CITY OF PORTLAND, MAINE

AP Rockledge Ave., Little Diamond Island

RE: Rockledge Avenue, Little Diamond Island

SUBSURFACE WASTEWATER DISPOSAL SYSTEM APPLICATION

Redmond Deck

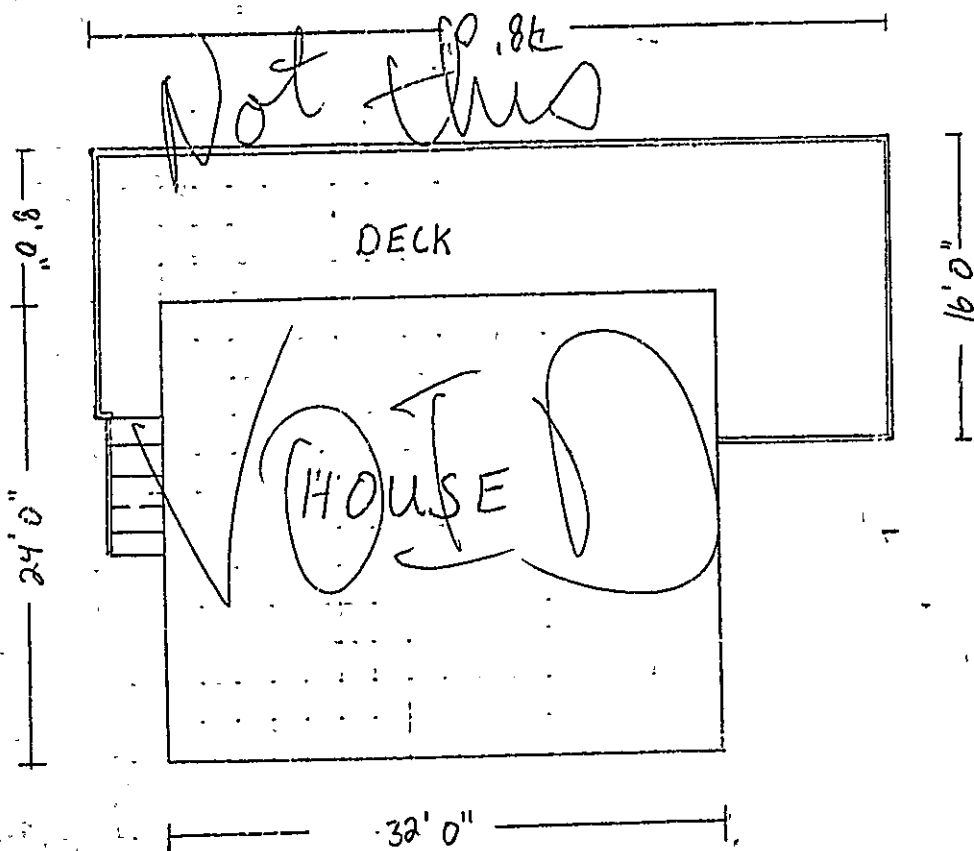
(*) Note edge of Bank on location map. Bank is over 50 ft. in height and deck would not be visible nor obtrude onto shoreline as seen fro. the water.

This letter is in regards to your application for a permit to construct a deck on your property at Little Diamond Island. I have reviewed this thoroughly since the shoreland zoning is in a state of change at this time. I have consulted with the City's Corporation Counsel and the D.E.P. in Augusta to be sure that my interpretation is correct regarding this matter. I believe the following regulations apply.

Section 12.C.1.a of the D.E.P. guidelines effective March 24, 1990 After January 1, 1989, if any portion of a structure is less than the required setback from the normal high-water line of a water body or upland edge of a wetland, that portion of the structure shall not be expanded in floor area or volume, by 30% or more, during the lifetime of the structure.

Section 12.C.1.c.
No structure which is less than the required setback from the normal high-water line of a water body, tributary stream, or upland edge of a wetland shall be expanded toward the water body, tributary stream, or wetland.

I have reviewed the preliminary boundary survey prepared by Paul J. Miller and found that the existing structure is within the 100' setback now required by the State of Maine. The proposed deck would be an expansion toward the water body.

Based on this information, I find that this permit is not issuable as submitted.

option #2
18x15

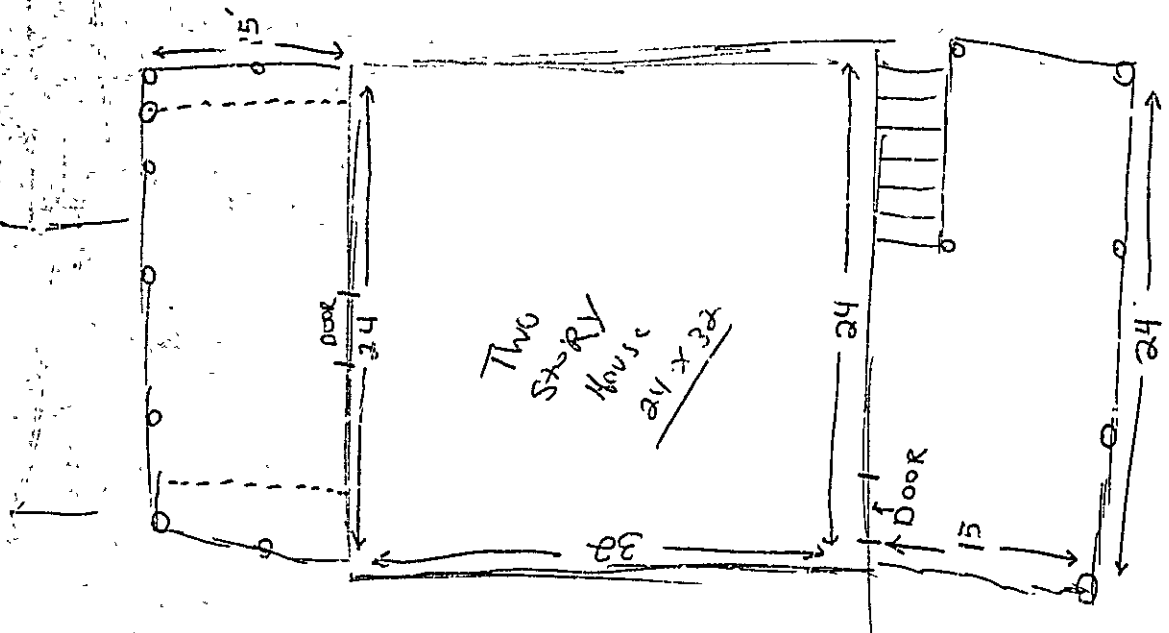
all construction to meet
code — less than 30%
expansion sideways
WDH
